Sandia Recommendations for UL 1699B

10-11 Sept, 2013

Photovoltaic and Distributed Systems Integration, Sandia National Laboratories

Current test setup.

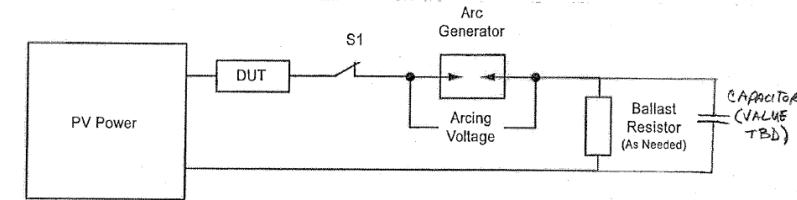
- Goal: Move toward realistic, repeatable arc-fault detection tests.
- Ballast resistor tests are unrepresentative of true PV systems.
 - Option 1: Only test using inverters.
 - Option 2: Add a capacitor in parallel to the resistor. [Lippert, PR19639]
 - Additional question: what capacitance should be selected? There's a large range of input capacitance values so should a reasonable mean be selected?
 - Option 3: Leave test the same.
- Experience: PV AFD prototypes have more difficulty detecting arc-faults with a resistive load bank than an inverter because there is no low AC impedance path without the inverter input bus capacitor.

Table 27.2
Arcing tests and clearing times

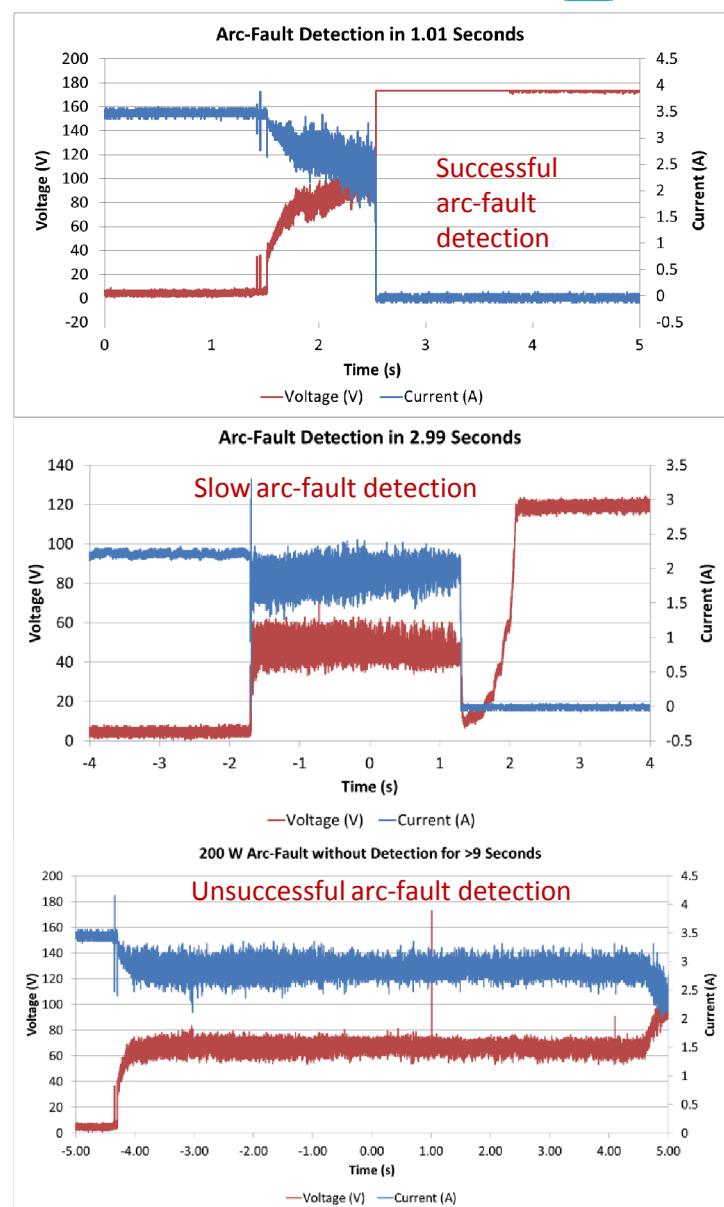
- These are also dangerous!
- 100 W arc-faults can easily start polymers on fire.
- Would like to see another row in Table 27.2 for 100 W arc-faults. These should to be included in the testing too.

Parallel arc-fault generation

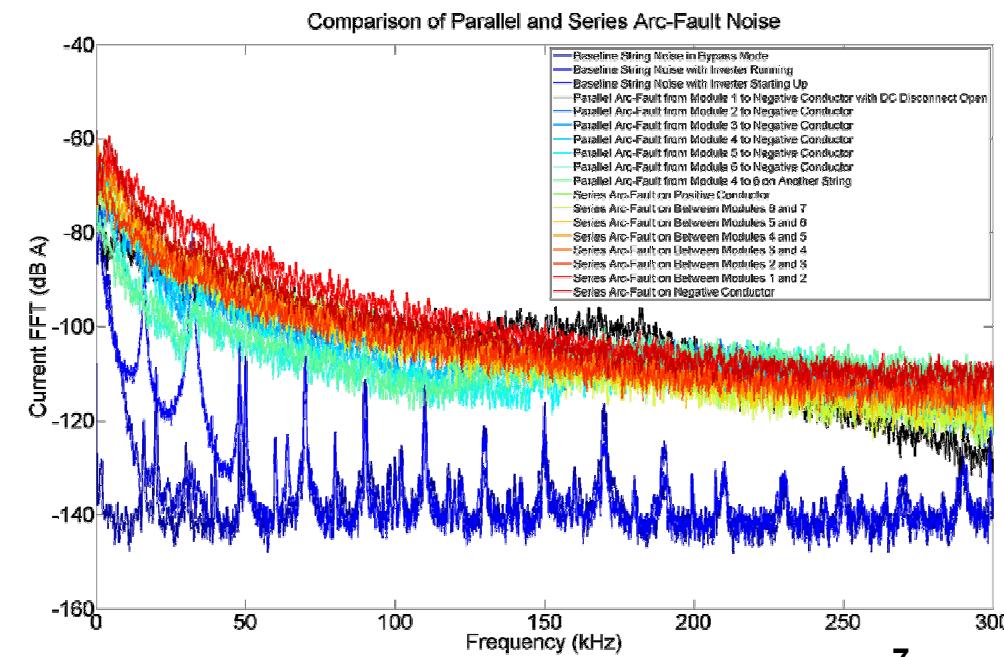
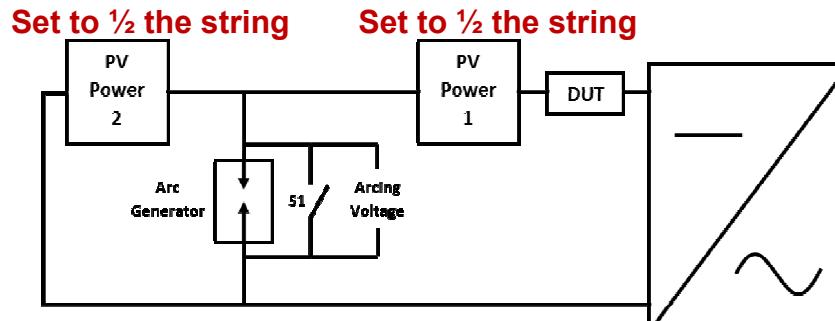
- Extensive testing at SNL shows that the arc-fault noise is very similar regardless of where the arc-fault is generated, so the parallel arc-fault should be created mid-string to prevent shorting the input bus capacitor of the inverter.
 - Realistic of true PV systems and repeatable.

A warning about PV simulators

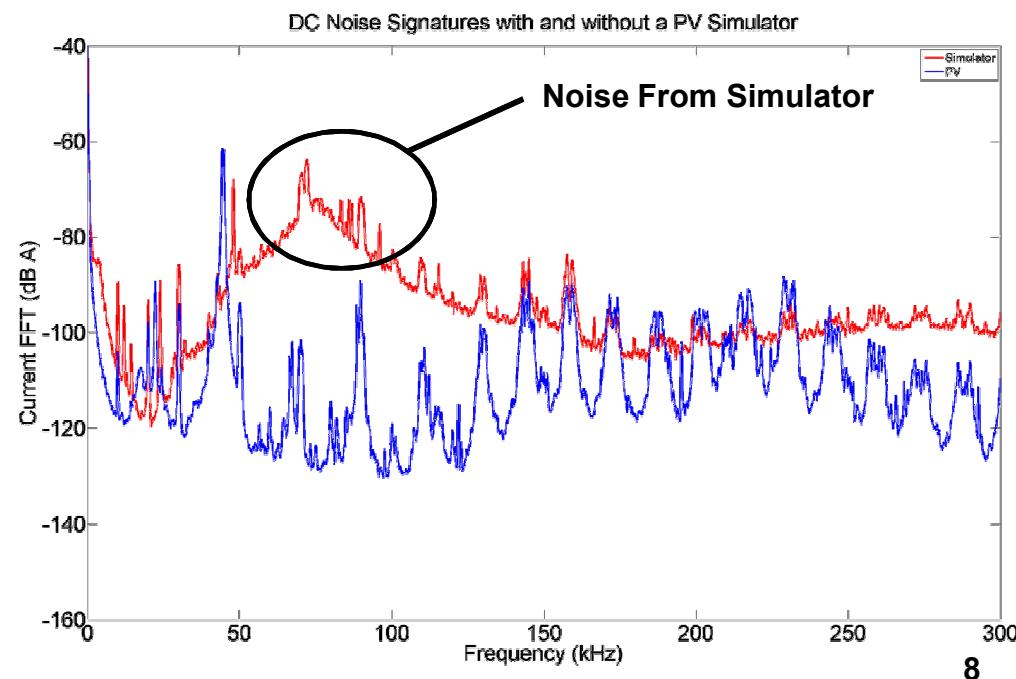
- These are switching devices so they inject their own noise into the DC system.
- Not all simulators are the same.
 - Must require strict constraints on DC noise injection.
- Sandia recommends using physical PV systems.
